Subject: Saxton Nuclear Experimental Corporation (SNEC)
Application for License Termination
Operating License No. DPR-4
Docket No. 50-146

**DISCUSSION ISSUES FOR MEETING BETWEEN THE NRC AND SNEC STAFFS
OCTOBER 31, 2002**

**** Almost Dry Well OP-3 16 2', OP-4 18 25', Geo-8 14 25' ***** Dry Well Geo # 3 17 25'

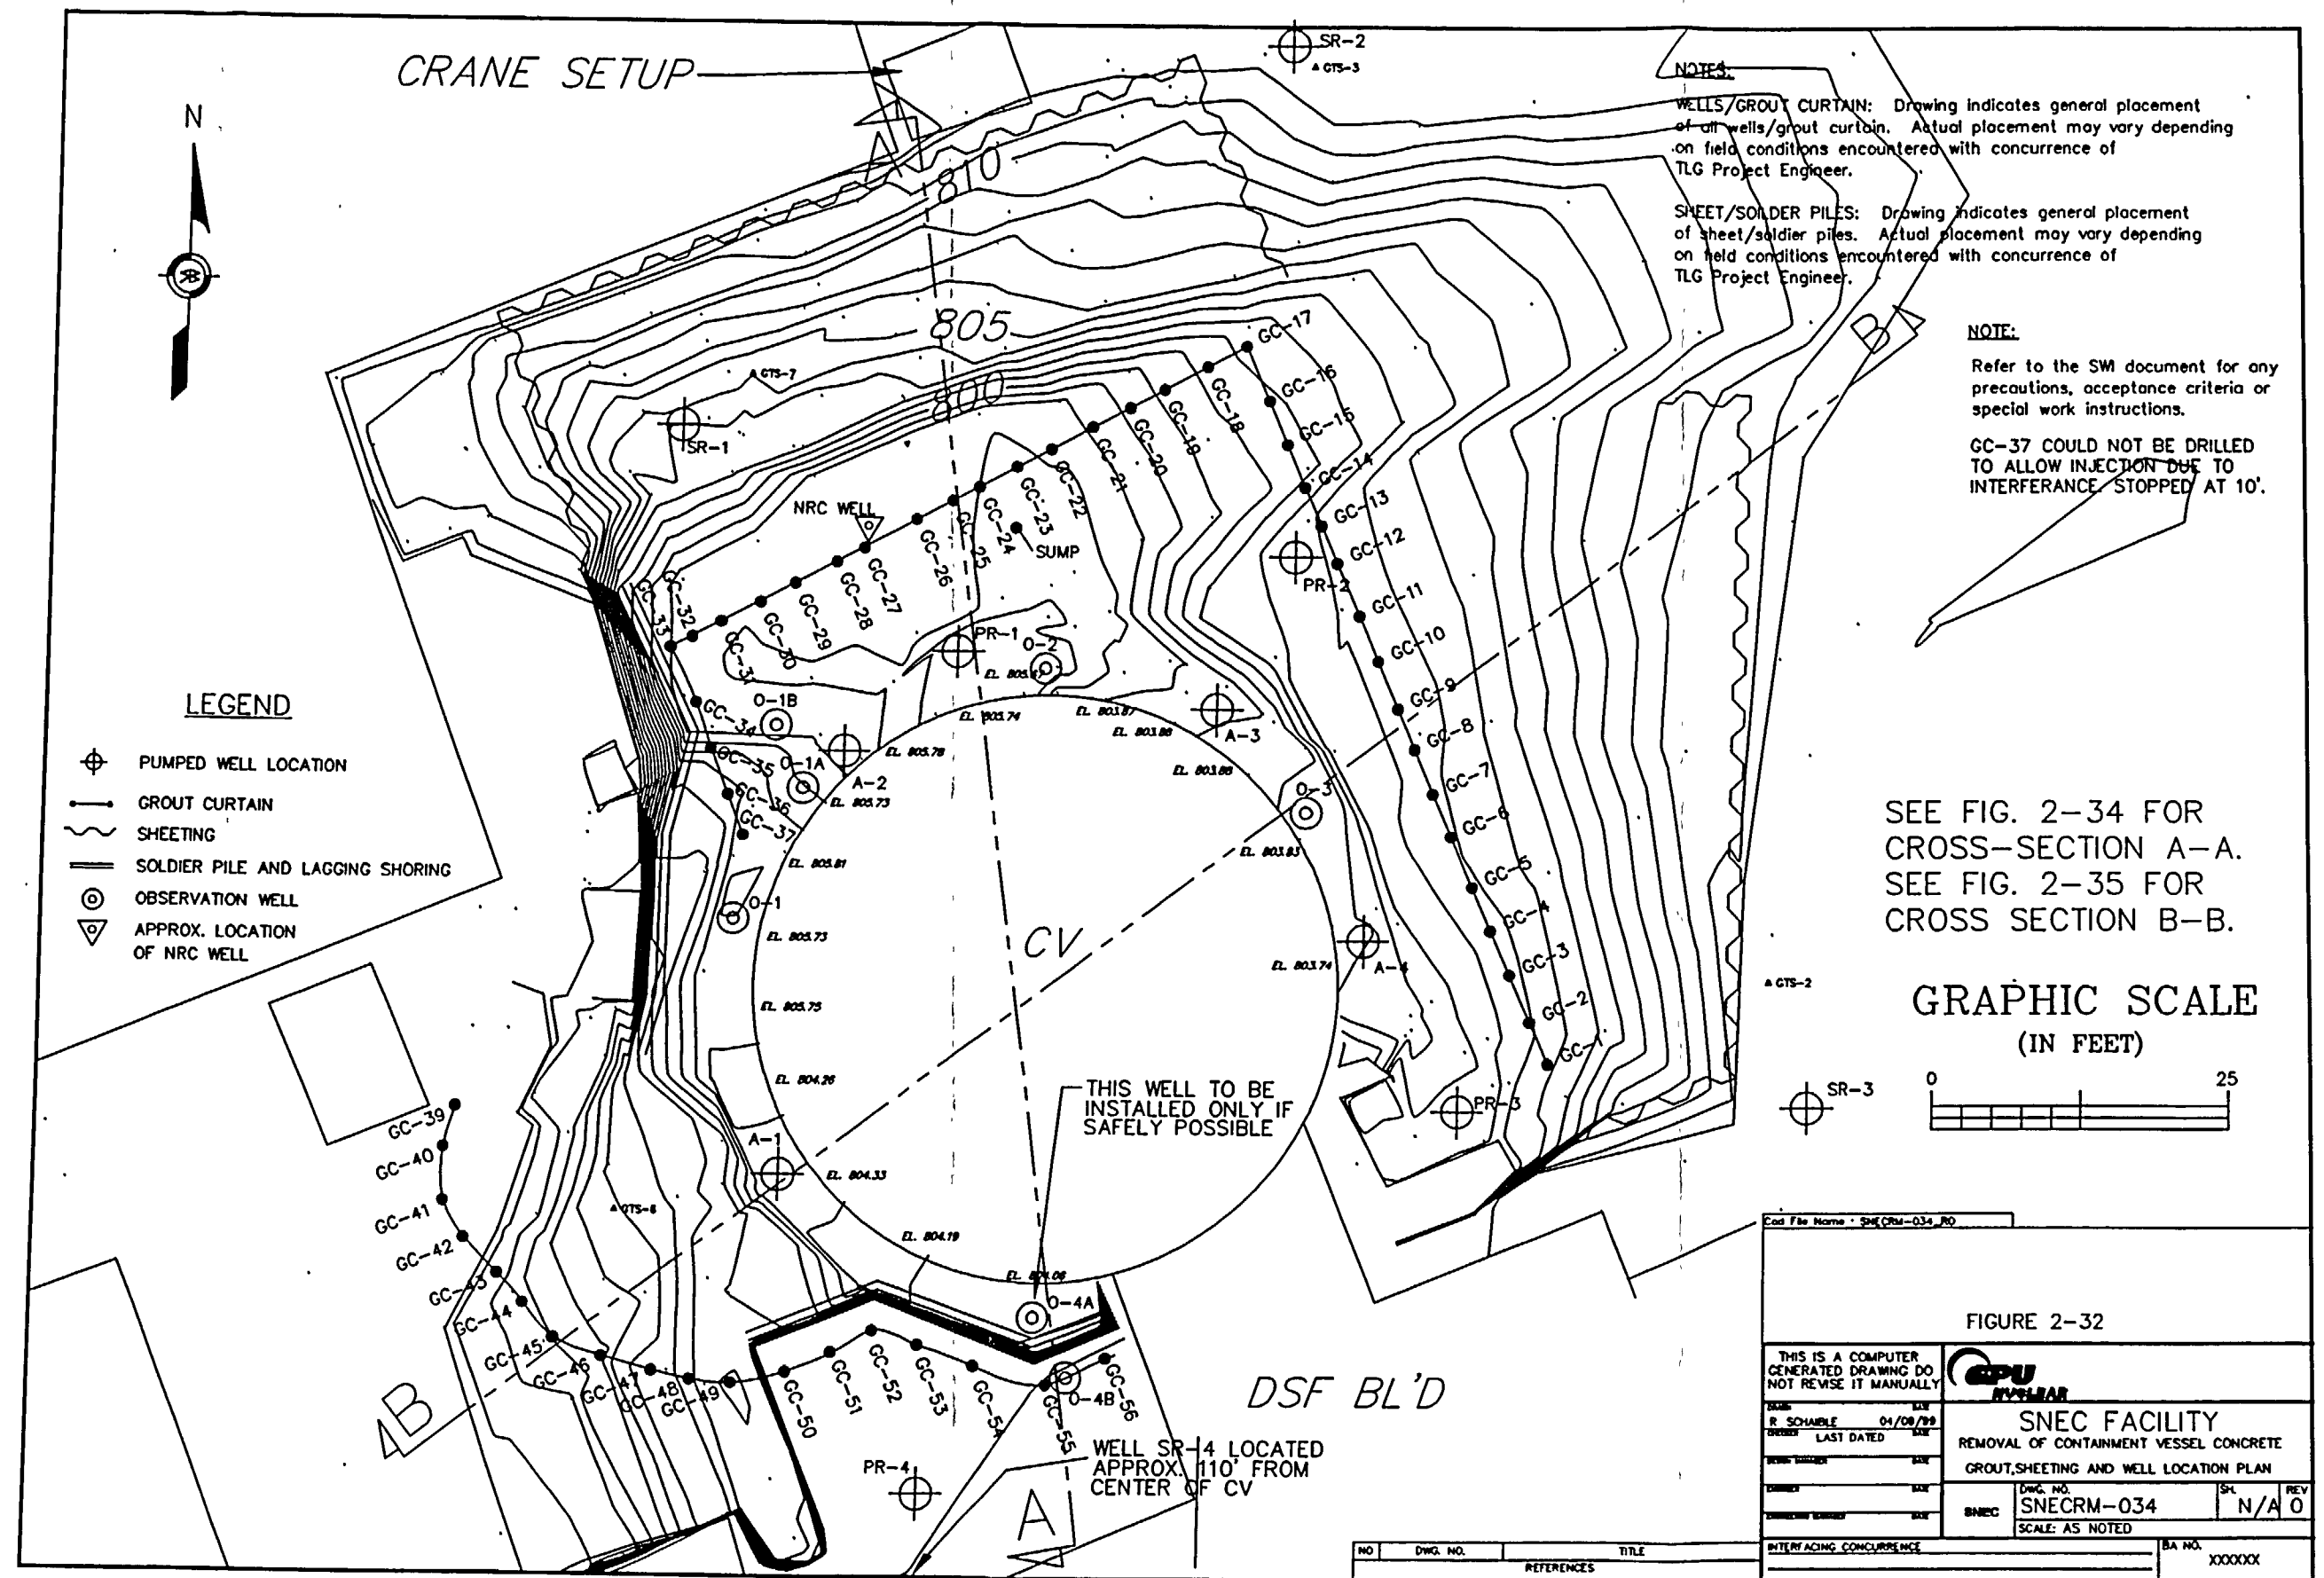
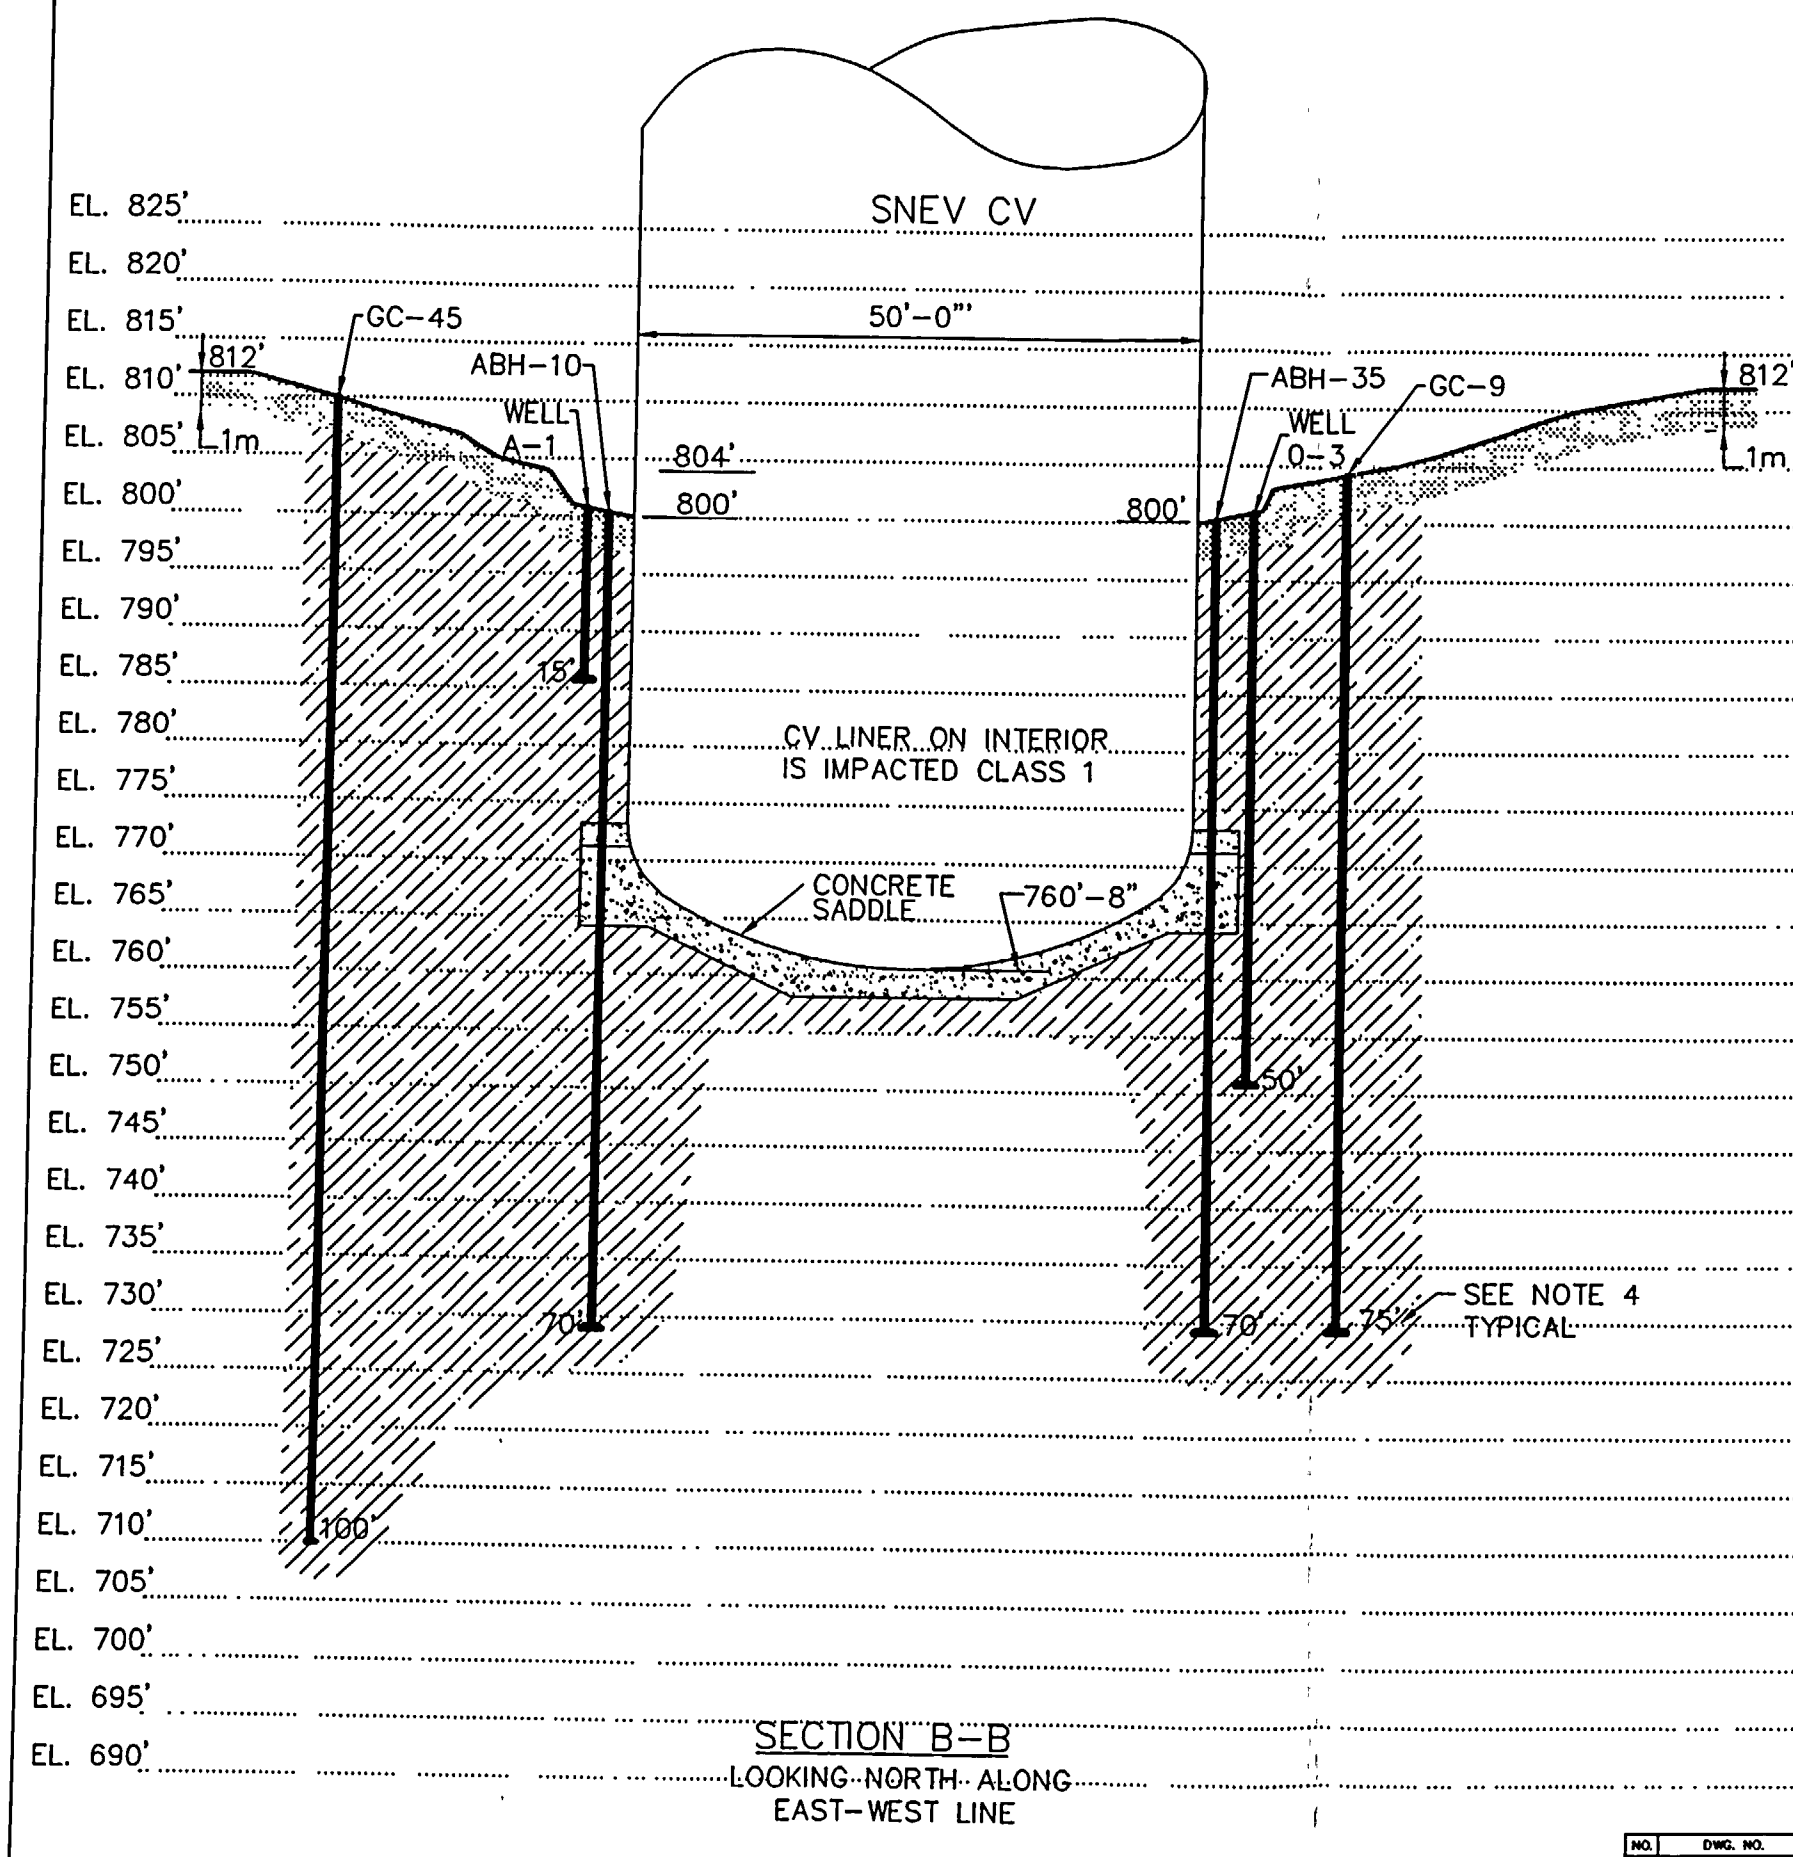
- c. Recent groundwater-level configuration maps representing the overburden and bedrock units. Also, discuss any changes in the groundwater-level configuration maps under drought and extremely wet conditions. The groundwater flow directions or patterns should be discussed and shown on the maps. The groundwater flow in the bedrock should also be discussed based upon observed water levels and the fractures and structural features in the bedrock units. (This information was not included in the LTP, but it was included in the items listed above.) The licensee should also provide a table that lists the groundwater levels over time at this site for the different monitoring wells. The licensee staff or consultants provided the NRC staff with a table with this information during the April 2002 groundwater sampling event. This table provides information on the variations in the groundwater levels during seasonal and wet and dry climatic periods.

Table 2-34 listing the most recent groundwater levels has been provided. In addition, Section 2.2.4.5.1, page 2-26, has been revised as follows to describe groundwater flows through the various geological units.
